## Application for Works Approval

**Works Approval Number** W6448/2020/1

**Premises** Narrogin Wastewater Treatment Plant

**Date of Report** 11/12/2020

**Figure 2: Daily inflows to the Narrogin WWTP (Water Corporation 2020a)**

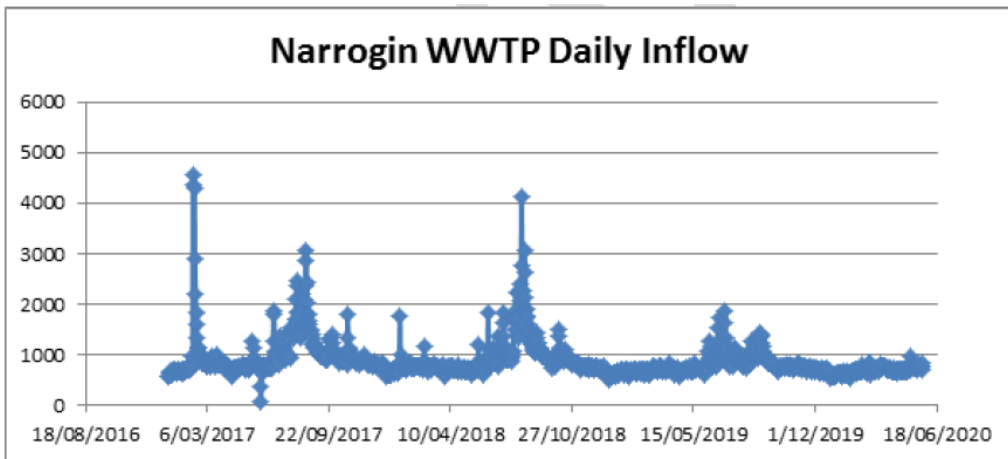
Figure 2 was provided by the Applicant and shows the daily inflow volumes to the wastewater treatment plant over a period of more than three years. There were three periods in which the inflow was greater than 3000 m<sup>3</sup>/day, with the largest daily inflow due to a wet weather event being approximately 4,400 m<sup>3</sup>/day in February 2017.

NA – Decision Report Section 2.2.	Confirmed that the high reading in Figure 2 from 2017 was a high rainfall event.	The Decision Report has been updated to reflect this.
	Confirmed that DWER's summary of the information provided within attachment 2B of the application is correct.
